# Appendix 1 – Amended Scheme Clarification Note.

- 1.1. **Refused Scheme** – General Arrangement (ref. 3223-01-03a and 3223-01-03b) and Landscape Proposals (ref. 3223-01-13) prepared by Axis.
- 1.2. **Amended Scheme** – Amended General Arrangement (ref. 3223-01- 03A Rev A and 3223-01-03b Rev A) and Landscape Proposals (ref. 3223-01-13 Rev A) prepared by Axis.
- 1.3. The annotated plan below shows the location of the amendments in the context of the whole site. The detail for each amendment is then set out on the following pages.

## Amendment A

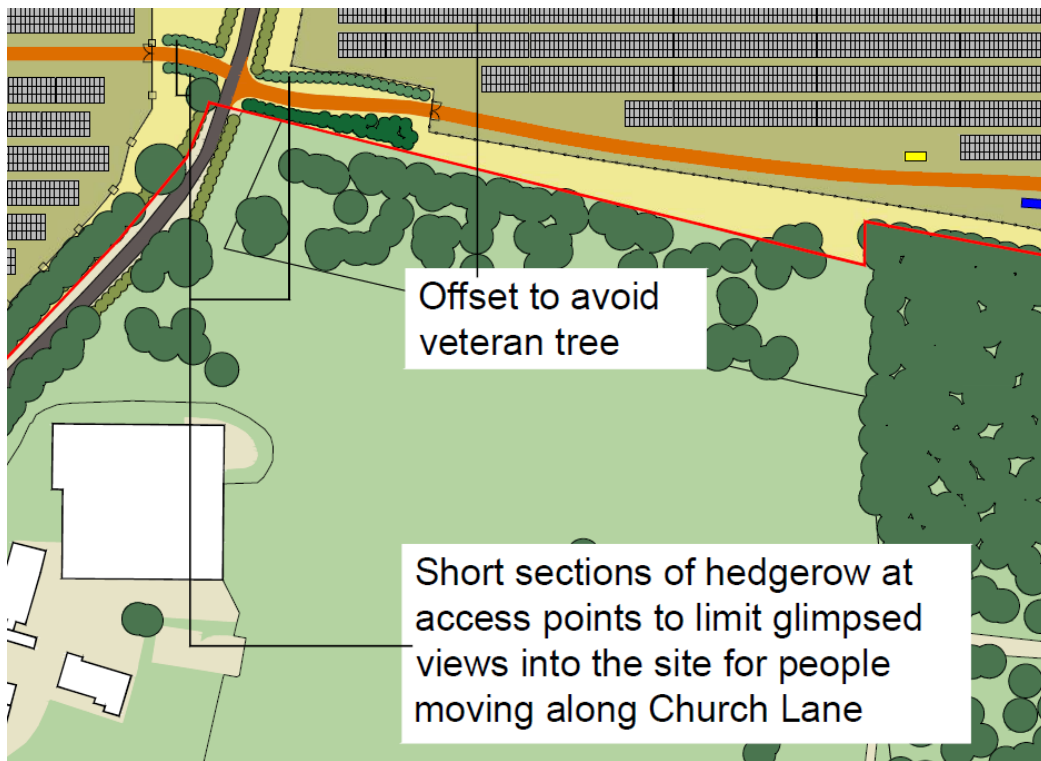
**Refused Scheme** – As originally proposed with fenceline closer to Church Lane.

**Amendment A** – Increased offset between Church Lane and the fenceline for the solar development on both the east and west sides. The increased offset allows for additional woodland belt planting to be incorporated either side of Church Lane, increasing screening, landscape integration, and habitat connectivity.

## Amendment C

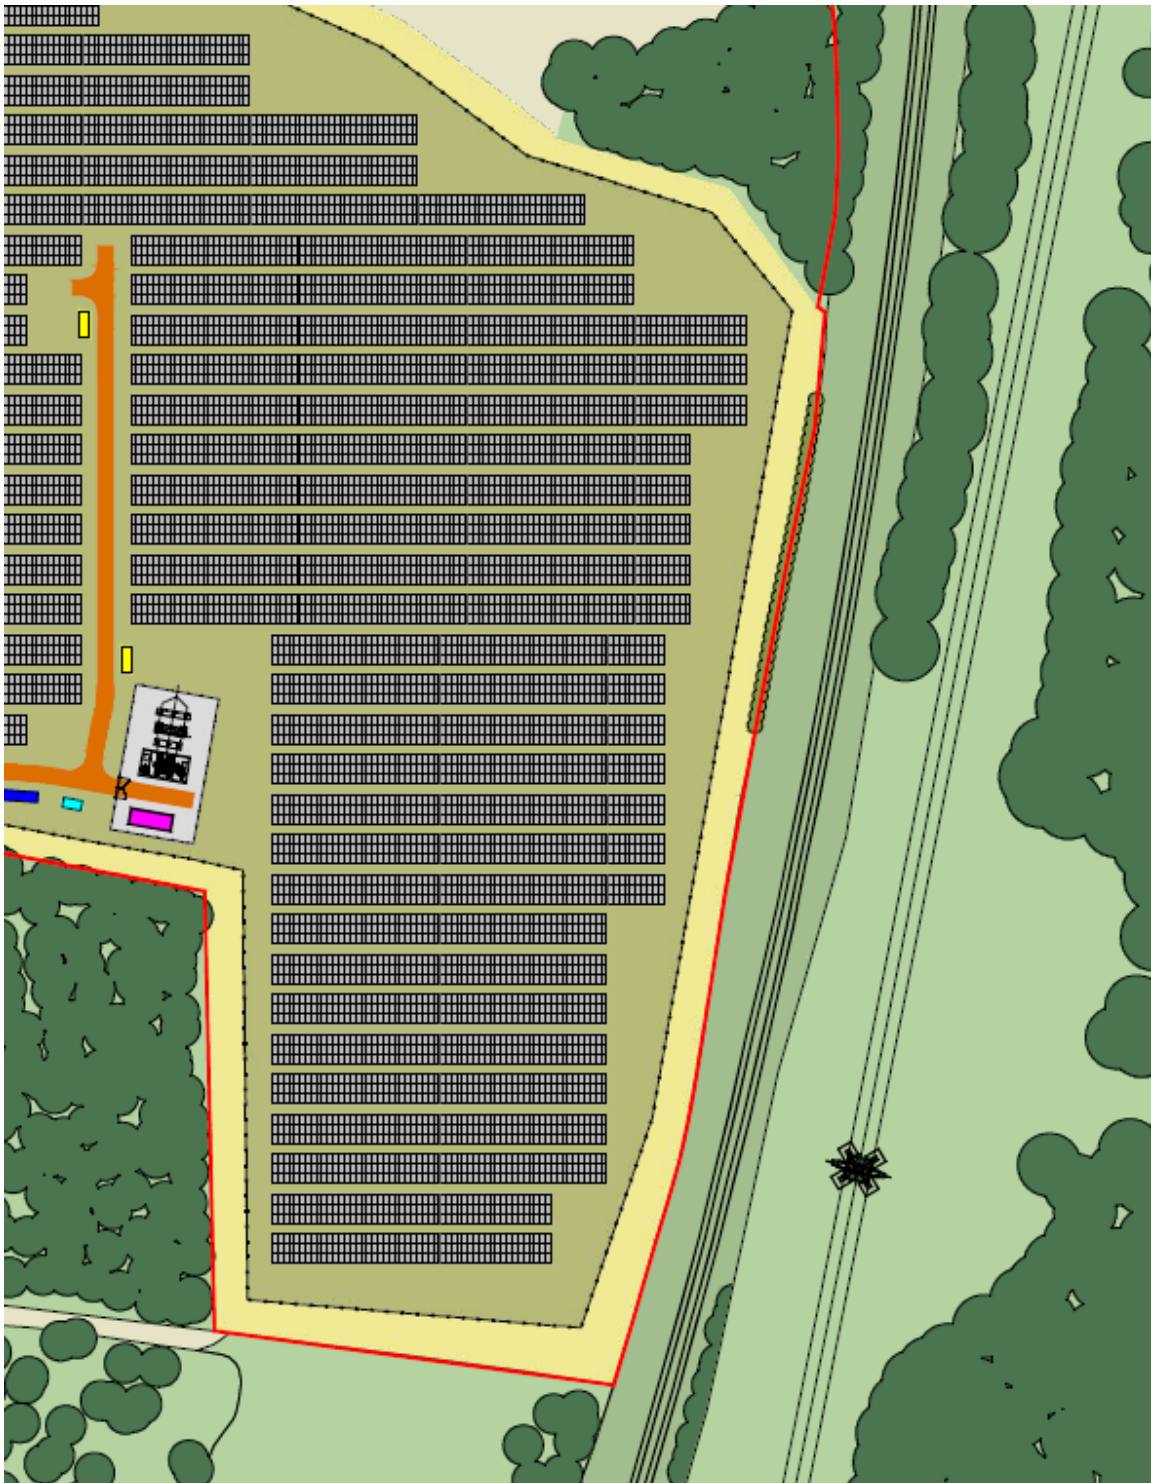
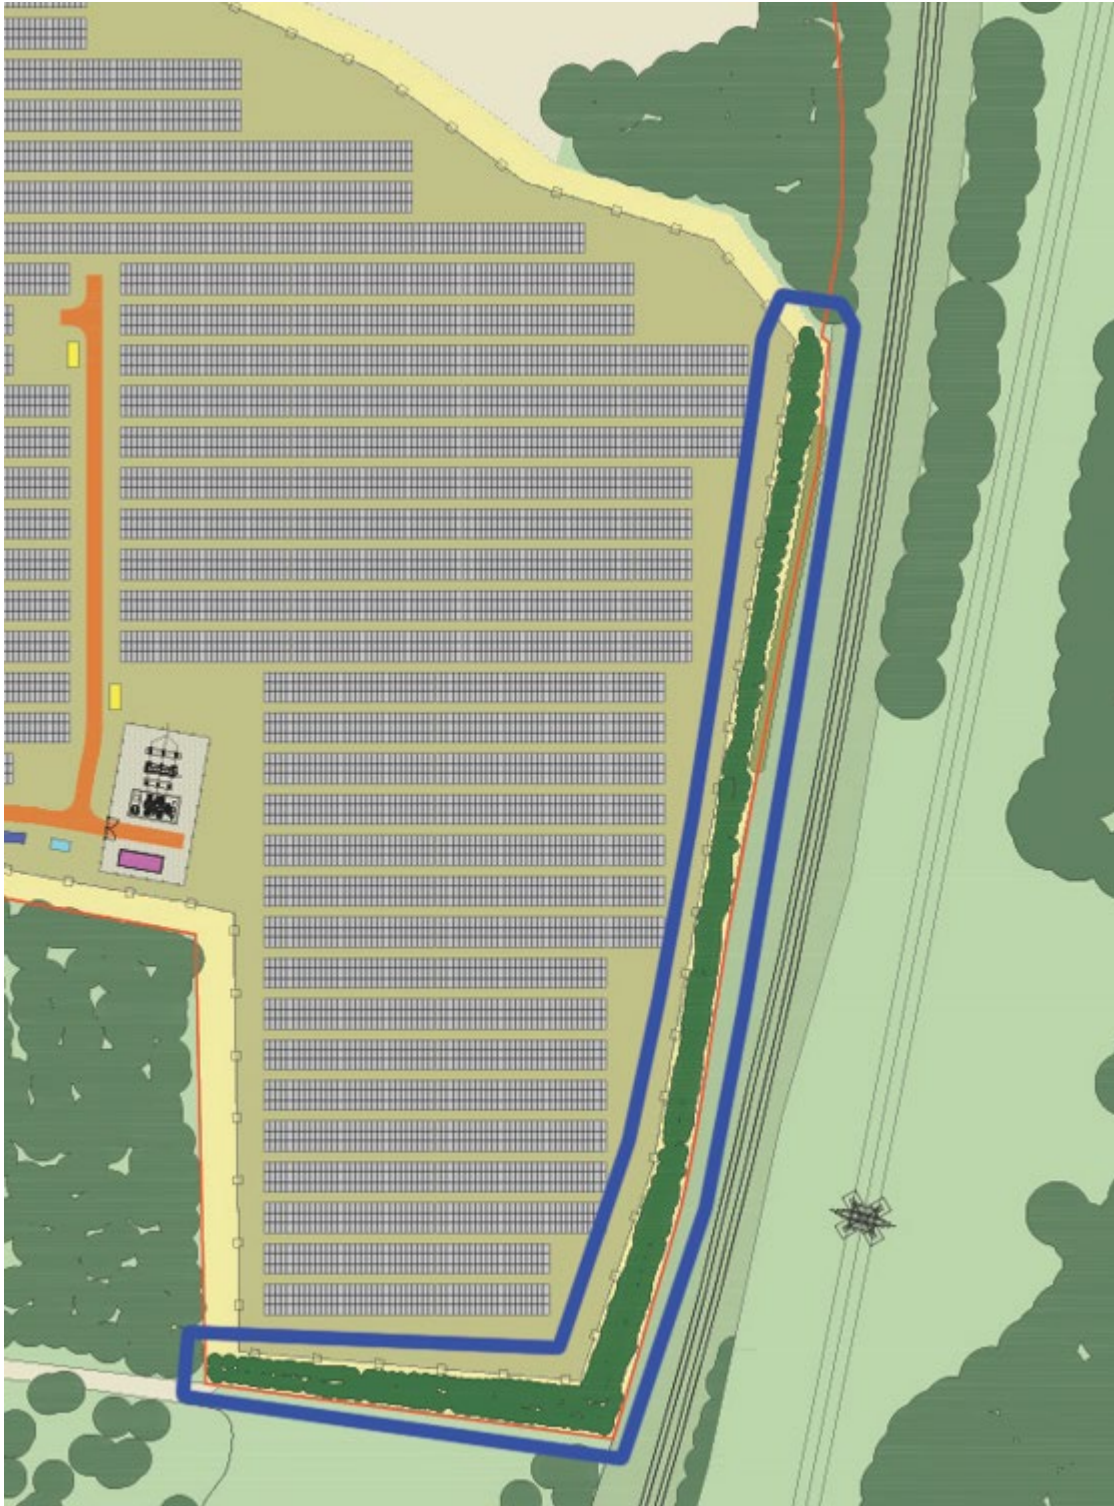
**Refused Scheme** – Limited additional planting on eastern boundaries.

**Amendment C** - Additional woodland belt planting along the southern and eastern boundaries of the eastern parcel to provide greater screening to this edge of the development, including between the solar farm and the railway line.

## Amendment D

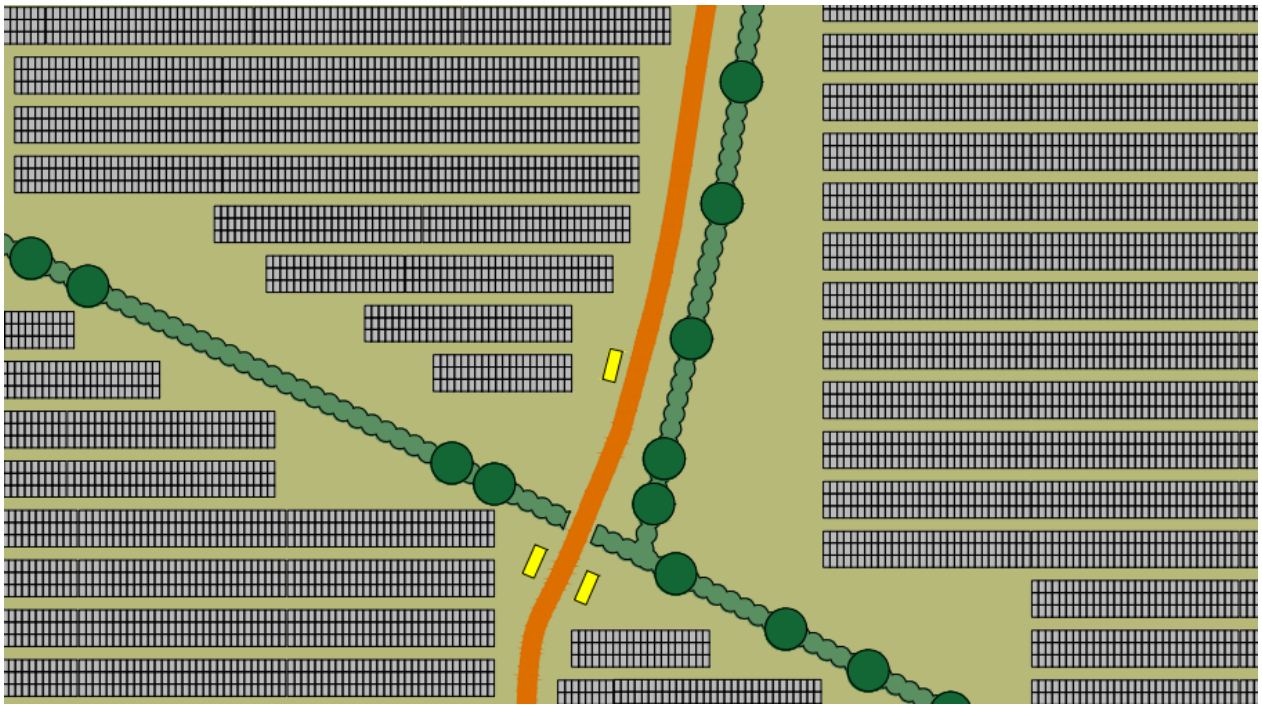
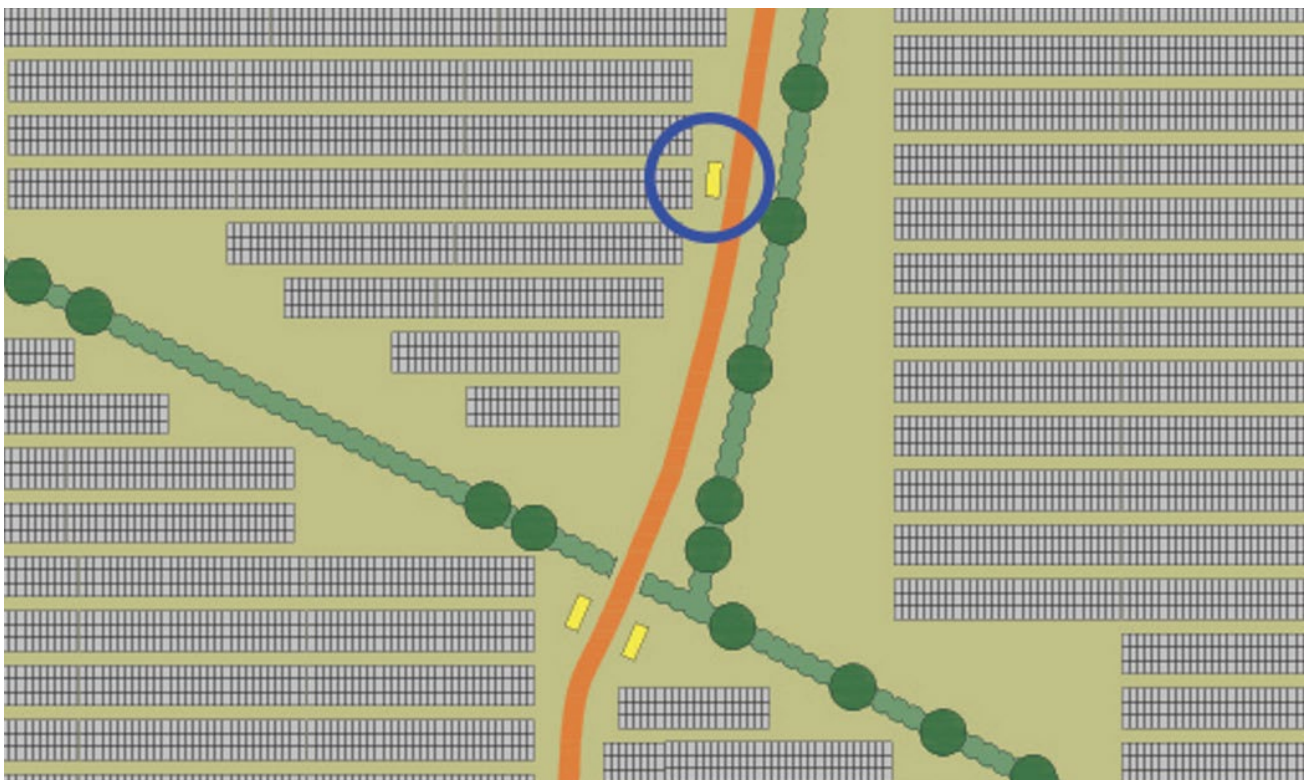
**Refused Scheme** - Proposed northern-most of the above three transformers within the central part of the western parcel.

**Amendment D** - A proposed transformer within the central part of the western parcel has been relocated further north slightly, for operational reasons.

## Amendment E

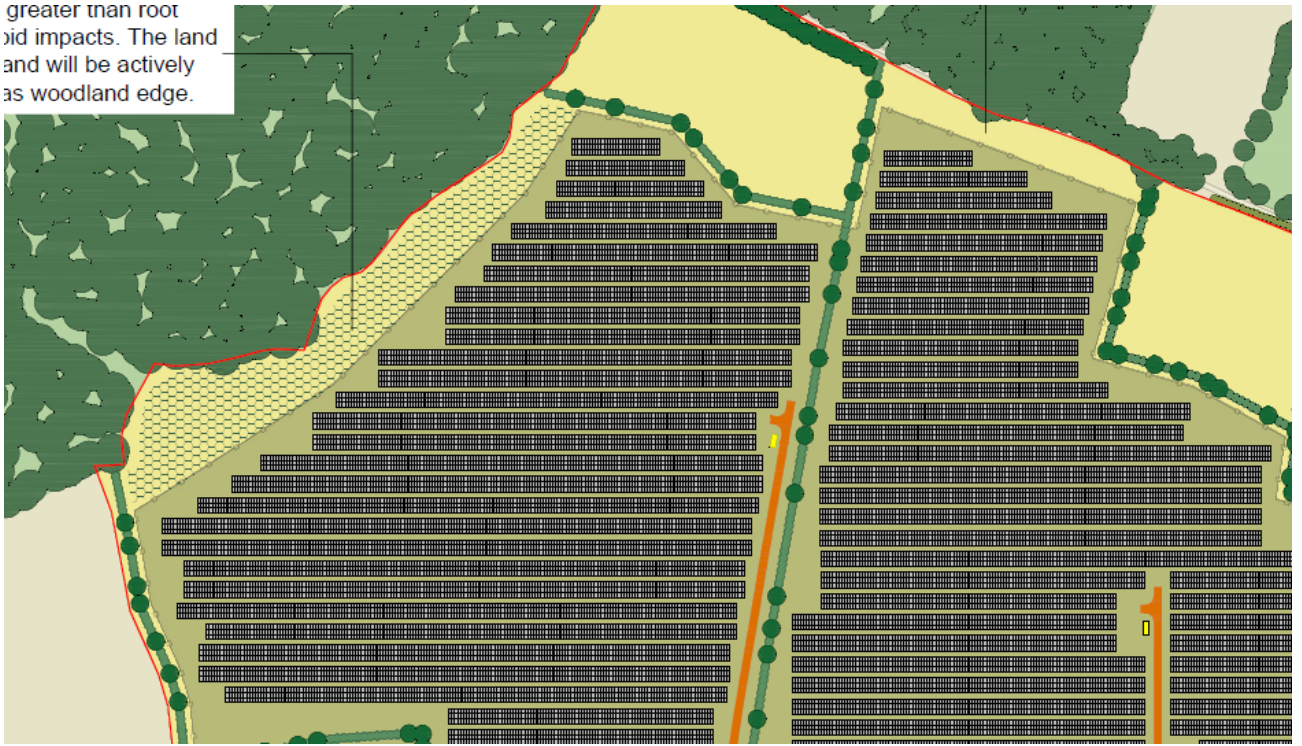
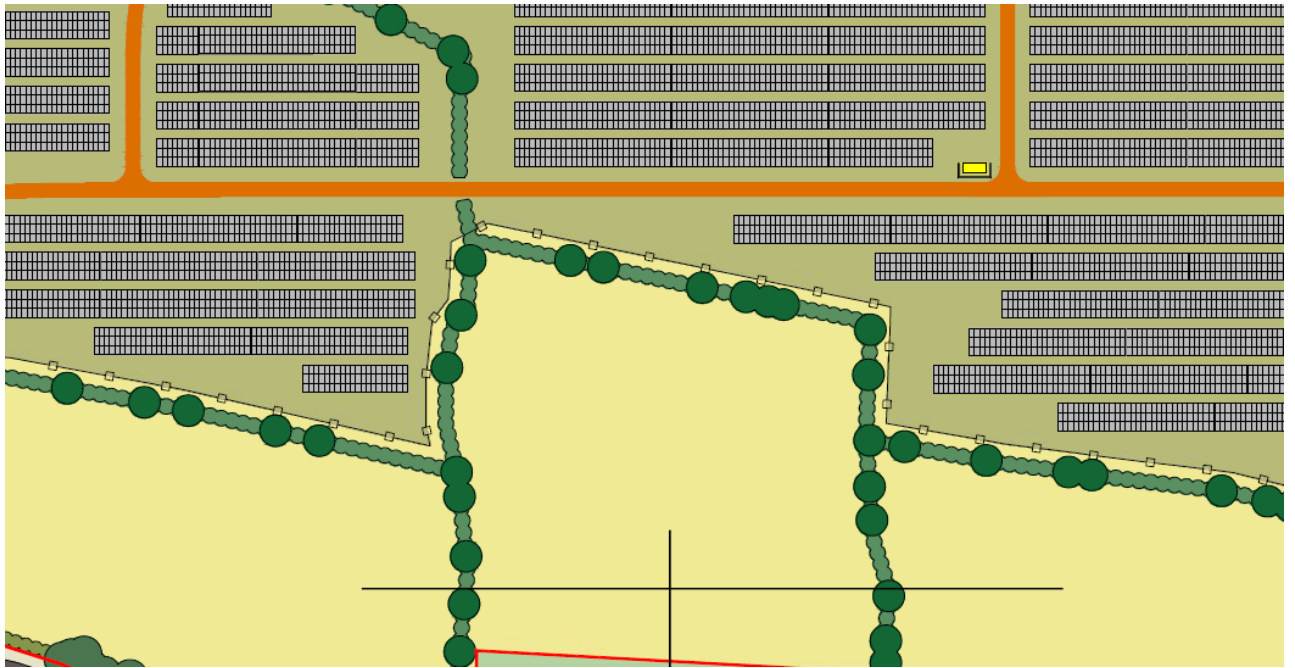
## Refused Scheme - No gaps in hedgerows for access

**Amendment E** - Gaps introduced to hedgerows to provide access between fields for agricultural purposes.
